848-570 Gearbox Bushing

TR 3B through TR 4A: 1st & 3rd gear bush
TR 250 & TR6 to (G) CF12500: 1st & 3rd gear bush

848-570_Instruction Fig 1

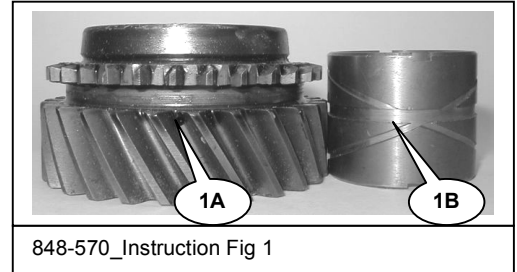
If we place an OE 848-570 (129940) bushing next to an OE 3rd gear 843-000 (105630), there is an obvious relationship between the hole in the gear (1A) and the main groove in the bushing (1B). The original bushings were made of "iron-bronze" and the bushings available today are made of brass.

848-570_Instruction Fig 2

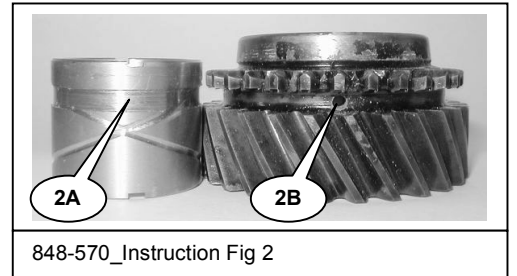
The oil hole was relocated in the later 847-080 (152772) gears and the groove in the bush followed. The later bush was made of steel. This improved the longevity of the bushing.

848-570_Instruction Fig 3

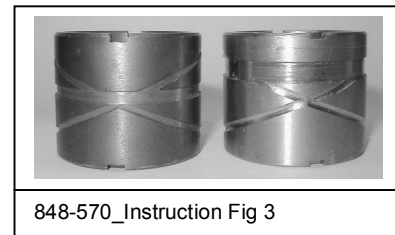
While it is logical to assume there is a relationship between the hole in the gear and the main groove in the bush, it turns out that the location of the groove does not matter very much if at all. The presence of the diagonal grooves provides enough lubrication no matter which bush is used. This is not supposition, it is fact. The later steel bushing was (and is) used to replace the early bush in high performance applications because they lasted longer. No one ever had a lubrication problem. In addition, the only bush we have sold since 1999 is a brass bush with the offset groove (2A). We have had no reports of trouble either here or in the UK. Please note that there is a bush available with the "early" groove pattern but we have found these to be 0.020" undersized and therefore not suitable for purpose.
